DEVELOPMENT DETERMINATION PANEL MEETING

WEDNESDAY 9 MARCH 2022

Agenda for a Meeting of the Development Determination Panel to be held on Wednesday 9 March 2022 via teleconference Commencing at 10:00am

3.1 DA2021/1698 - 68 Bower Street MANLY - Alterations and additions to a dwelling house including a swimming pool, spa and garage 5

Image: Street elevation - minor revision to include similar planting setback.

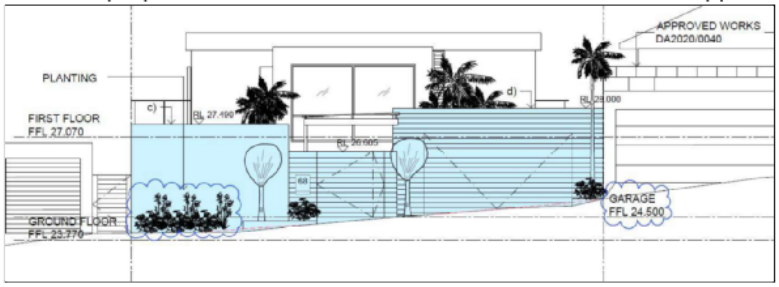
- The Manly DCP seeks complementary design and visual improvement to the streetscape and it is noted that the proposal generally relies on the situation that properties along the northern side of Bower Street have "walled-out" their front setback areas with garages, high solid fencing and the like with limited landscaping. In this case the proposal is adding a further garage building in the front setback and while the existing outbuilding (that is the original converted garage is to be demolished and rebuilt as a cabana and lawn area. The applicant has amended the plans to provide a 1.0m setback with landscaping space that is consistent with the current frontage and removed proposed bin room from in front to maintain a similar appearance the existing frontage.

Image: Spa position with grassed roof to create 'grotto' and pool with plant area under with replacement retaining walls.

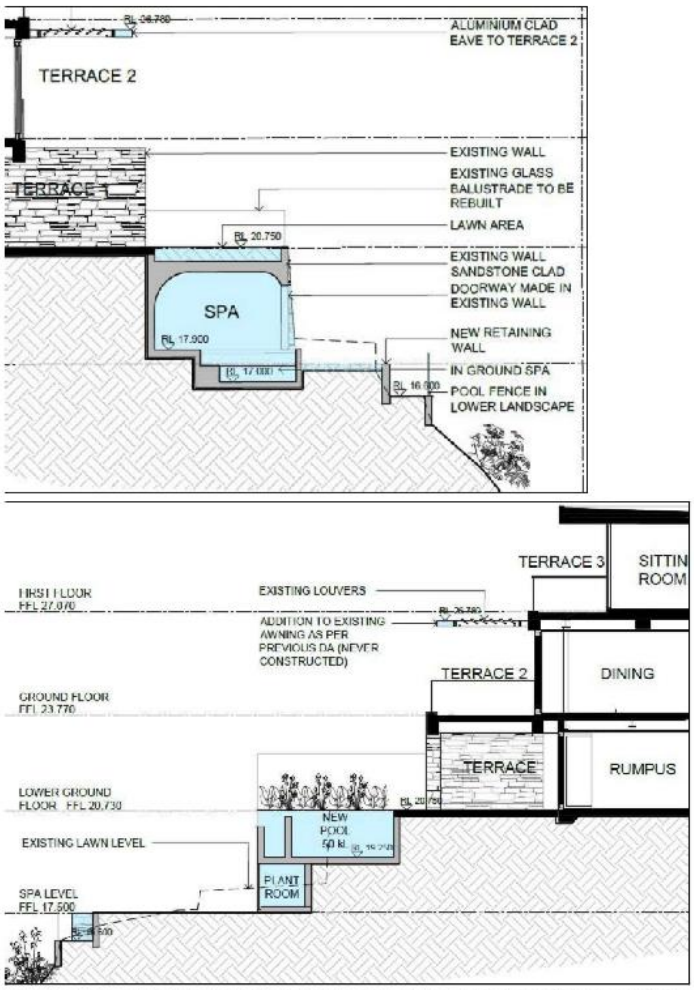
- The location of the pool is consistent with the placement of the adjacent pool in the rear private open space area and appropriate to the DCP. The pool is being replaced with a rectangular shape and has a minor variation to the DCP being positioned with a standard 0.9m (BCA type setback) to the southern side boundary. The setback to the southern side boundary is which is consistent with adjacent setbacks, despite the site being on steep terrain above the Manly to Shelly Beach walk. The setback to the escarpment is consistent with the existing in-ground pool.

- The new pool replaces an existing pool which generally maintains the current relationship of privacy (visual and acoustic) to adjacent land, including the position of the plant equipment situated below the main living area terrace. The pool includes landscaping toward the northern setback and is integrated into the escarpment area which is consistent with the pattern of development in the vicinity of the site along Bower Street. The pool is not visible from Bower street and is partly screened from view along the public walkway of Manly to Shelly Beach due to the steep terrain. Landscaping works are outlined on the landscape plan which will reinstate with mixed and native shrubs and ground cover with a small grassed terrace.

Image: Replacement sandstone wall, steps, spa 'grotto' and reshaped pool area with balustrades and associated landscaping.

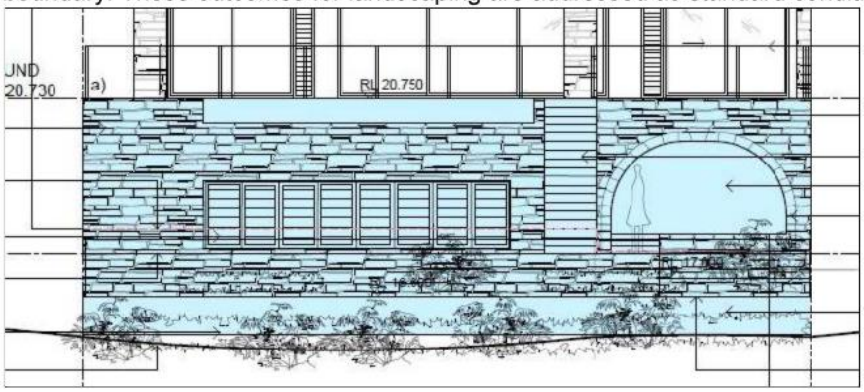
- New landscaping works are proposed that will re-instate lawn areas, native shrubs and ground covers to assist with the retention of wildlife corridors and habitat, including long-nosed bandicoot sites. The site is not readily accessible for fairy penguin habitat due to the vertical rock and ledges between the northern boundary and the ocean water line. A terrestrial biodiversity report has addressed native habitat consideration for the site, including recommendations to allow for wildlife movement within and between suitable points along the boundary. These outcomes for landscaping are addressed as standard conditions.

under cl 4.6(4)(a)(i) that the written request has adequately addressed this matter: see Four2Five Pty Ltd v Ashfield Council [2015] NSWLEC 90 at [31].

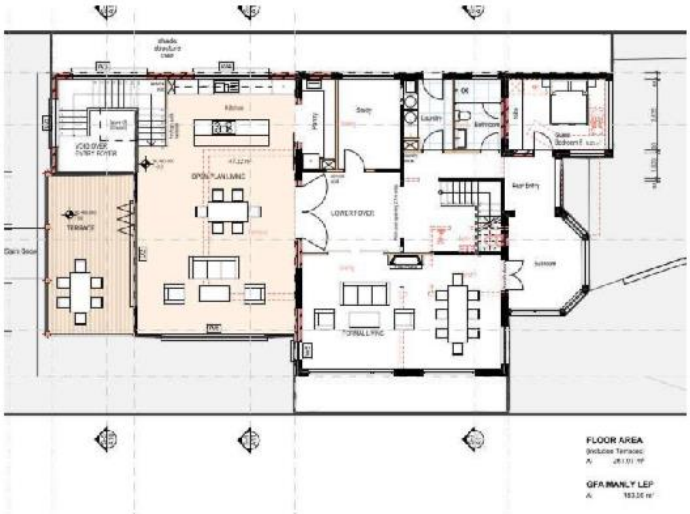
Concern was raised in regards to the suitability of the proposed terraces and windows proposed under this application. Following Council raising concerns with the applicant in regards to privacy, amended plans (dated 21 October 2021) were lodged by the applicant which deleted the elevated terrace to the rear of the dwelling house and reduced the size of the ground floor terrace to the front of the dwelling with the terrace to the southern side of the dwelling deleted.

Figure 2 – Approved DA Plans on the left showing a 1.8m sill height for Window 16, compared to the proposed Window 16 as constructed on the right with a sill height of 1.5m.
Source: Stamped DA Plans (DA 2020/0842) and Proposed Architectural Plans

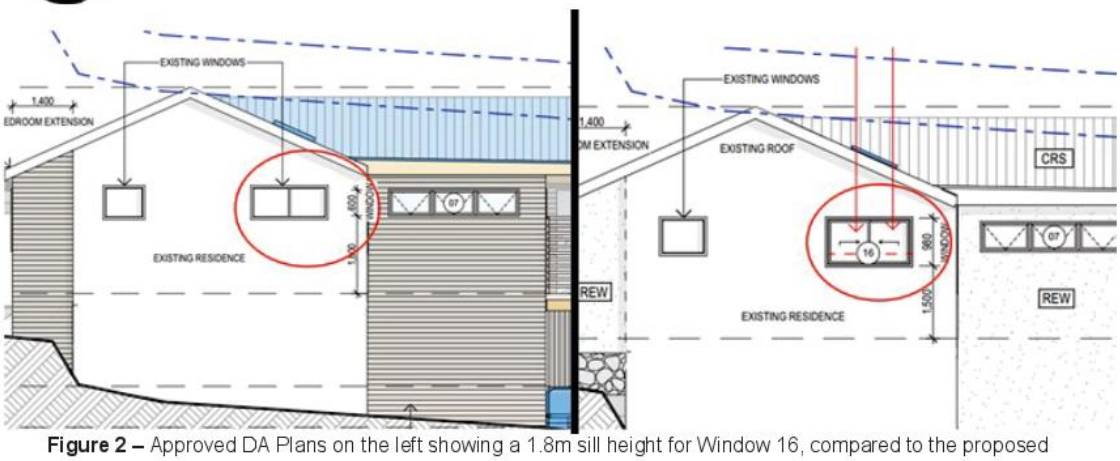
The submission raises concerns with the increasing size of Window 16. As demonstrated in ***Figure 2*** below, the DA was approved with a sill height of 1.8m, however the modification seeks consent for a sill height of 1.5m, as has been constructed and is shown in ***Figure 3*** and ***Figure 4*** below.

The submission objects to the overlooking opportunities this window presents to the living areas of the adjoining dwelling at 14 McDonald Street, and resultant loss of visual privacy.

The proposed modification seeks to increase the size of Window 16 by lowering the approved sill height from 1.8m to 1.5m (*refer to **Figure 2***). Consequently, this has meant the development is now non-compliant with the following privacy controls and objectives set in D8 of the DCP.

The proposed window enlargement does not comply with D8 of the DCP as there are multiple clear lines of site into the adjoining property to the south (*refer to **Figures 3** and **4***). Therefore, the modification to Window 16 is not supported.

Figure 5 – Western elevation of the dwelling house presenting to McDonald Street. Noted is proposed changes to two taller narrow windows for Window 6A and 6B to match Window 15.
Source: Applicant's submitted West Elevation

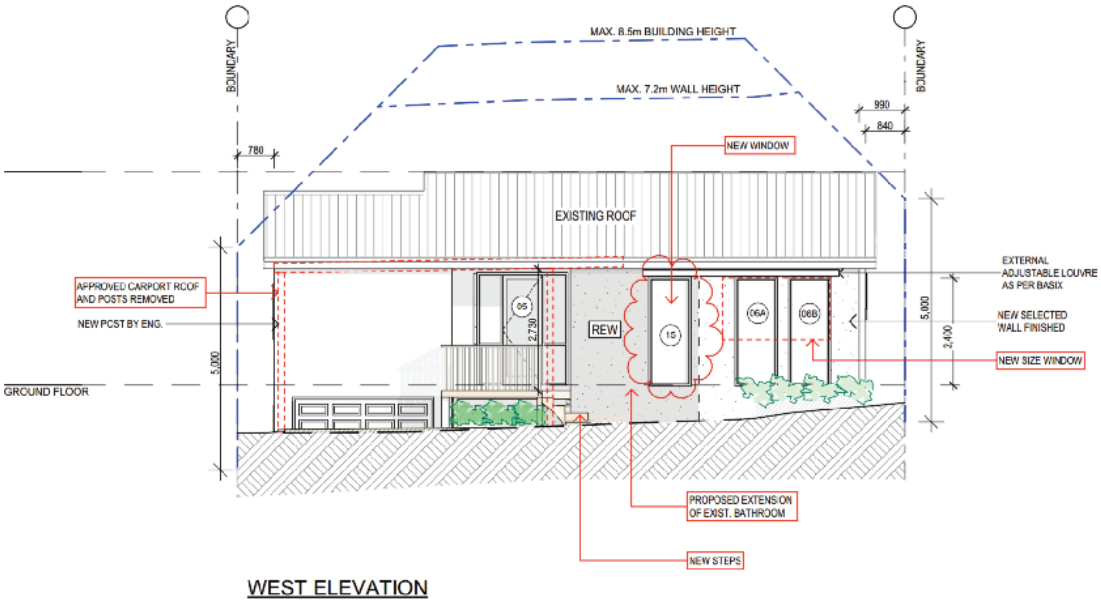
Window 6A and 6B are located on the building's front elevation facing west toward McDonald Street. The proposed modification sees Window 6 being split into two tall narrow windows to match the new Window 15 adjacent for the internally modified bathroom – refer to ***Figure 5*** below.

Accordingly, the modifications to these windows are deemed satisfactory.

Image 1: *Building Height non-compliance*

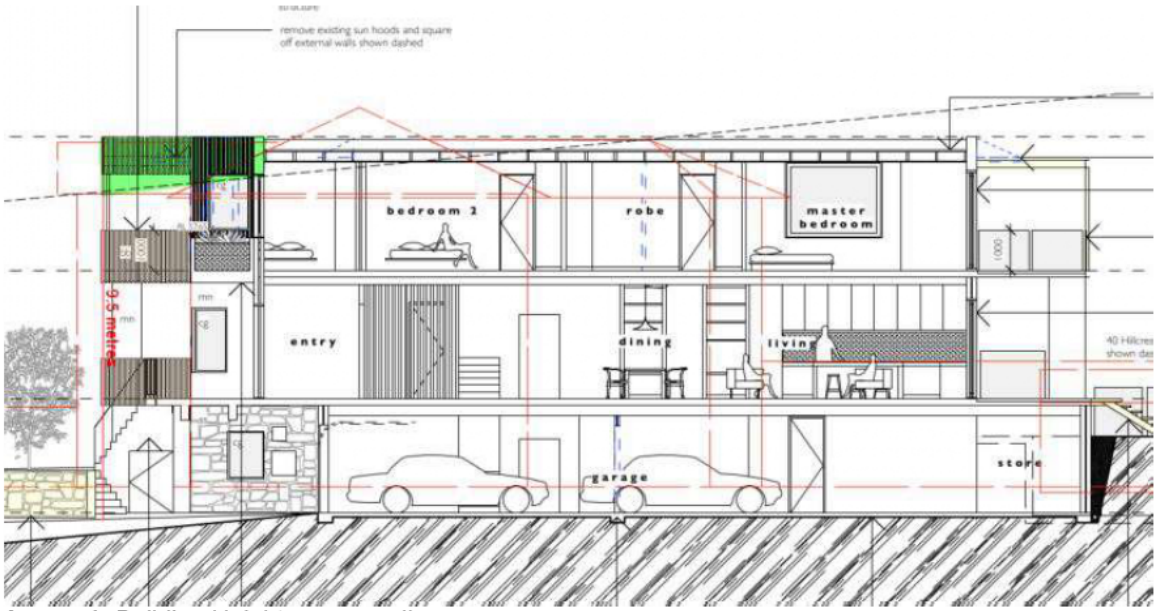
Development Standard:	Height of Buildings
Requirement:	8.5m
Proposed:	9.5m
Percentage variation to requirement:	11.76%

Image 3: *North elevation side boundary envelope encroachment*

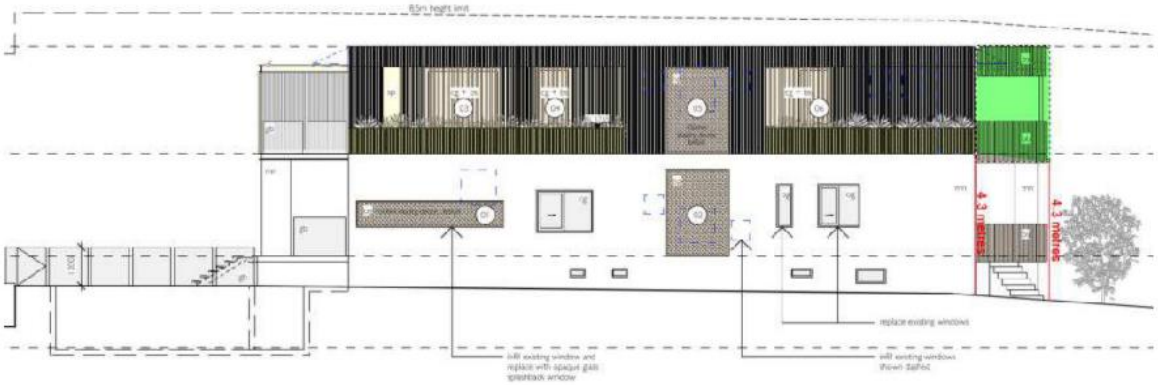
The proposal has a non-compliance to the building envelope on the northern and southern elevation. It is noted that the existing dwelling does not comply with the side boundary envelope on both the north and south elevations. The extent of the new building envelope non-compliance is shown in the figures below (highlighted in green):
